Series 90 180cc

Variable Displacement Pump

Charge pump design change

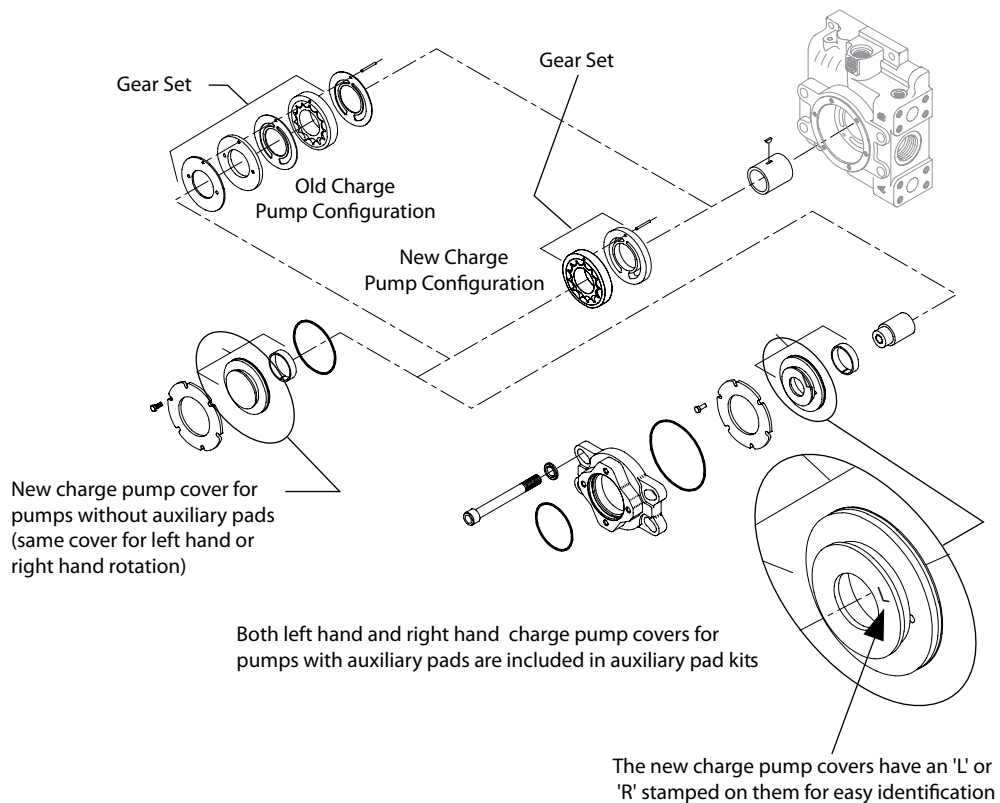
Change occurred at serial number N-94-06-xxxx.

Side cover design change

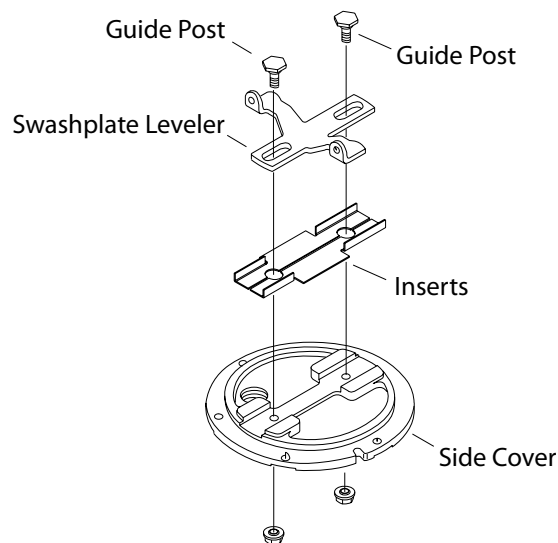
As a product improvement, Sauer-Sundstrand is changing the side cover and swashplate leveler (T-Bar) guide post design.

The new design side cover will have two hardened inserts in the machined slot which serves as a guide for the swashplate leveler, and modified guide posts. The swashplate leveler does not change.

Change occurred at serial number N-96-08-xxxxx.

Control Gasket Location:

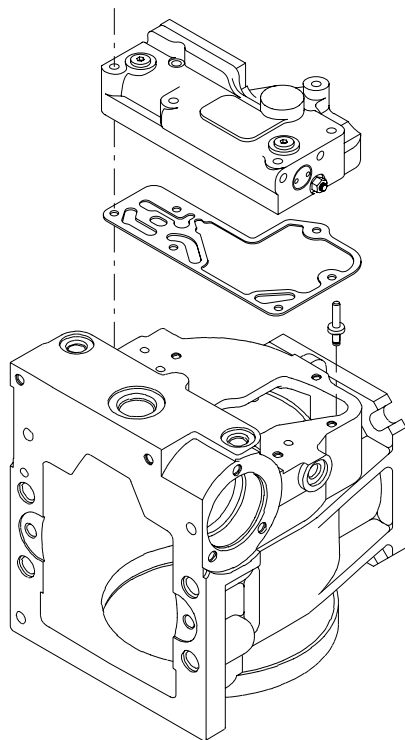
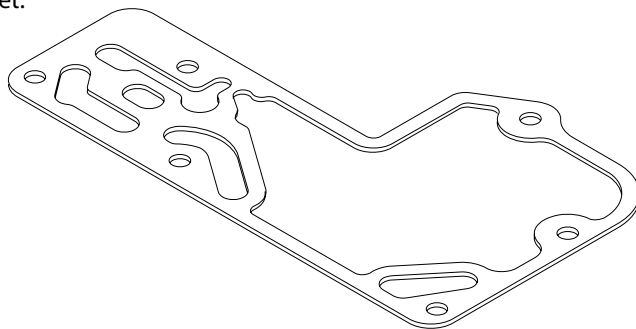
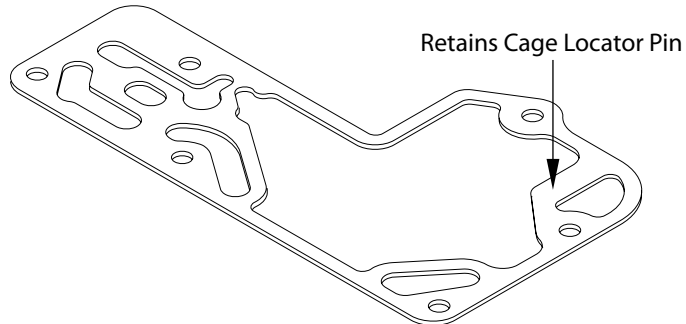
To address this situation, Sauer-Danfoss has introduced a design modification to the control gasket. The modification will insure that the cage locator pin is retained in 75cc pumps in all circumstances, while still maintaining the desired gasket clamp load to avoid leaks.

The new gasket is completely interchangeable with the previous gasket. Sauer-Danfoss recommends that the previous control gasket be replaced immediately on 75cc pump assemblies, with controls noted above, in which the control is on the side or on the bottom of the pump. The pump serial numbers involved are A-98-41-xxxxx through A-99-49-xxxxx. It is not required to replace the gasket in pumps with the control in the up position, until the initial servicing of the pump assembly.

SAE A auxiliary mounting flange, O-ring seal

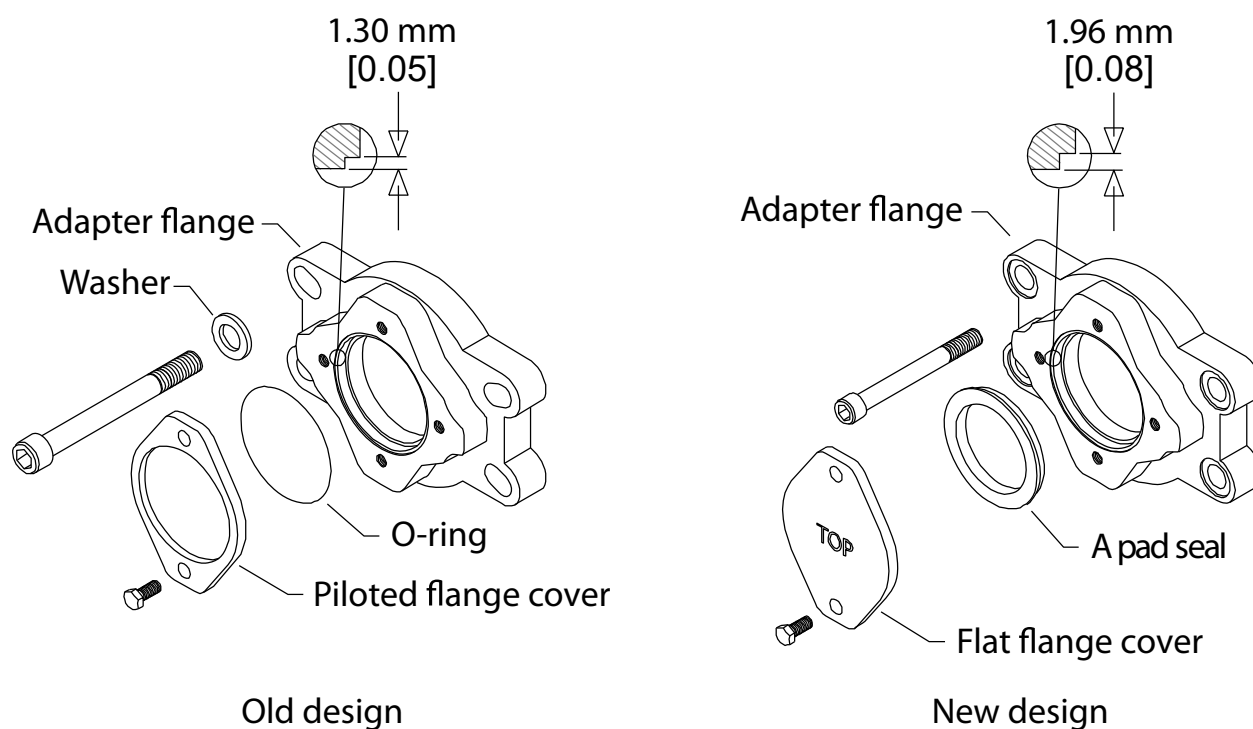
Sauer-Danfoss is pleased to announce a design improvement on the SAE A auxiliary mounting flange adapter on its series 90 pumps. The frame sizes affected by this change are 42, 130, 180 and 250cc. All manufacturing locations producing these pumps will be changed to this configuration.

The pumps will now be supplied with the donut style seal and new flat cover, instead of the small O-ring and stepped cover plate (shown in the drawing below).

Change became effective at serial number N-09-30-xxxxx. (20 July 2009)

SAE B auxiliary mounting flange, O-ring seal

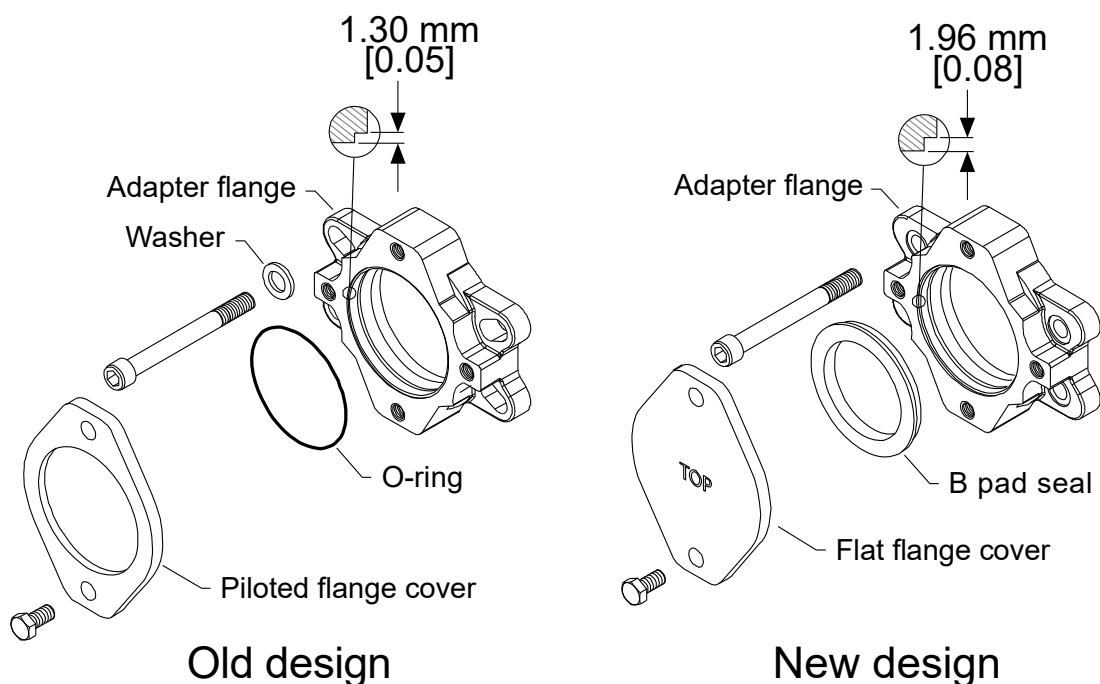
Sauer-Danfoss is pleased to announce a design improvement on the SAE B auxiliary mounting flange adapter on its series 90 pumps. The frame sizes affected by this change are 42, 130, 180 and 250cc. All manufacturing locations producing these pumps will be changed to this configuration.

The pumps will now be supplied with the donut style seal and new flat cover, instead of the small O-ring and stepped cover plate (shown in the drawing below).

Change became effective at serial number N-09-30-xxxxx. (20 July 2009)

SAE C auxiliary mounting flange, O-ring seal

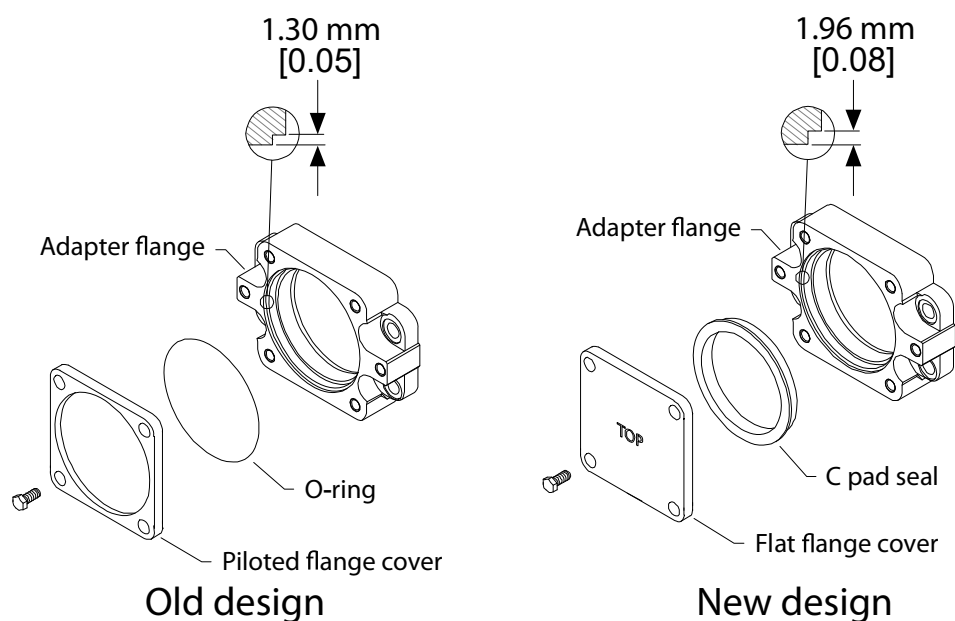
Sauer-Danfoss is pleased to announce a design improvement on the SAE C auxiliary mounting flange adapter on its series 90 pumps. The frame sizes affected by this change are 130, 180 and 250cc. All manufacturing locations producing these pumps will be changed to this configuration.

The pumps will now be supplied with the donut style seal and new flat cover, instead of the small O-ring and stepped cover plate (shown in the drawing below).

Change became effective at serial number N-09-30-xxxxx. (20 July 2009)

Pump redesign

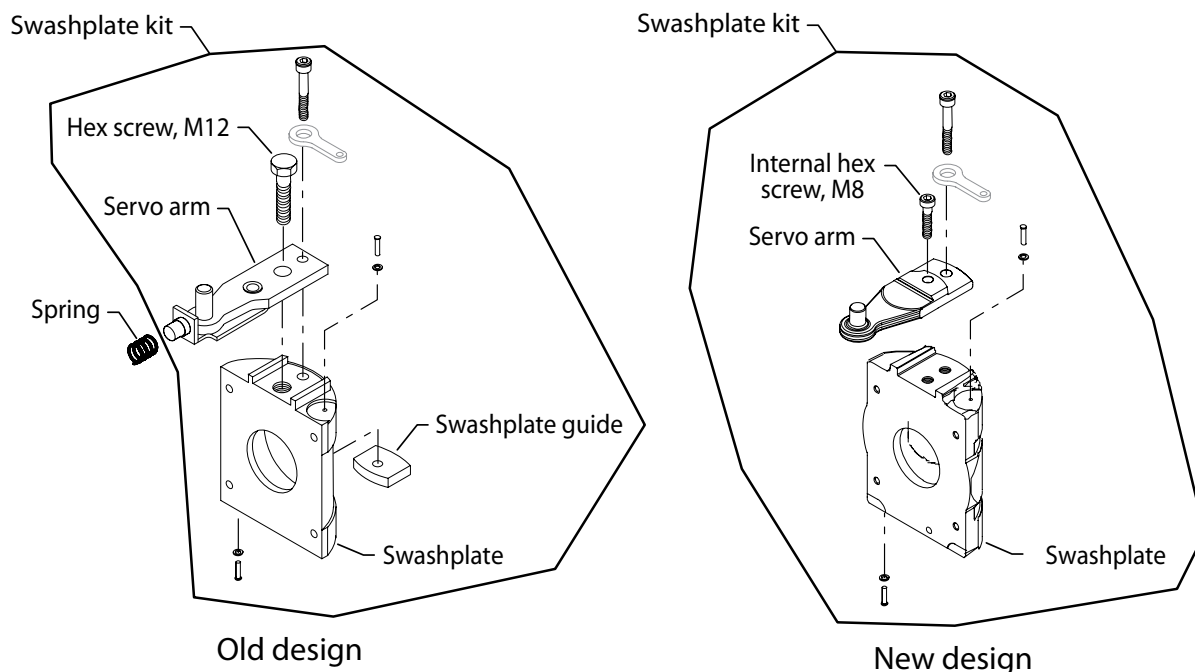
As a global improvement, the series 90 180/250cc pumps have redesigned the following components: servo arm, servo arm screw, swashplate guide and pump housing. This is a non-interchangeable change. Model numbers and order codes will not be changed.

A “one piece” servo arm is introduced. The pin that engages the servo piston is now machined as part of the servo arm instead of pressed in. The old servo arm will remain available as a service part for a period of time.

The swashplate position is now guided by the fit between the servo arm and the pump housing. A “shelf” on the servo arm fits under a boss in the housing to provide a fixed clearance. The swashplate was previously held down with a spring and bracket, which was riveted to the servo arm. The servo arm to housing clearance now limits lateral movement of the swashplate. The swashplate guide that was bolted to the bottom of the swashplate has been removed. The old swashplate guide will remain available as a service part for a period of time.

The housing is modified internally to provide the servo arm pivot. The old housing will remain available as a service part for a period of time.

This change became effective at serial number A-11-40-xxxxx. (3 Oct 2011)

Shaft seal change

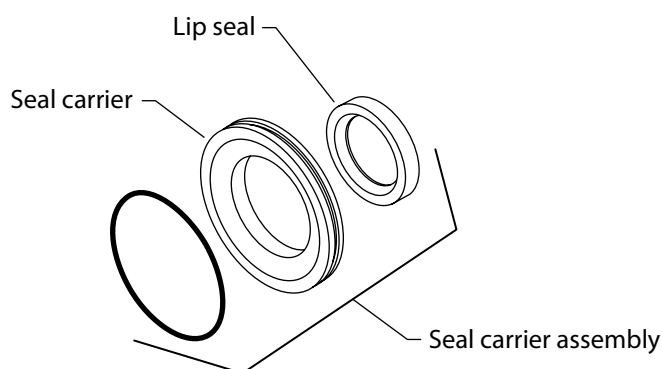
A supplier change for the shaft seal used in Series 90 180 and 250cc pumps has been made as part of globalization of the entire Sauer-Danfoss product line. The new lip seal has a smaller O.D., and the I.D. of the seal carrier changed accordingly. The old lip seal and seal carrier will become obsolete and not available for service.

The seal carrier assembly part number has changed to better track this change. The new seal carrier assembly is interchangeable, but the piece parts are not.

This change became effective at serial number N-12-17-XXXXX (25-Apr-2012)
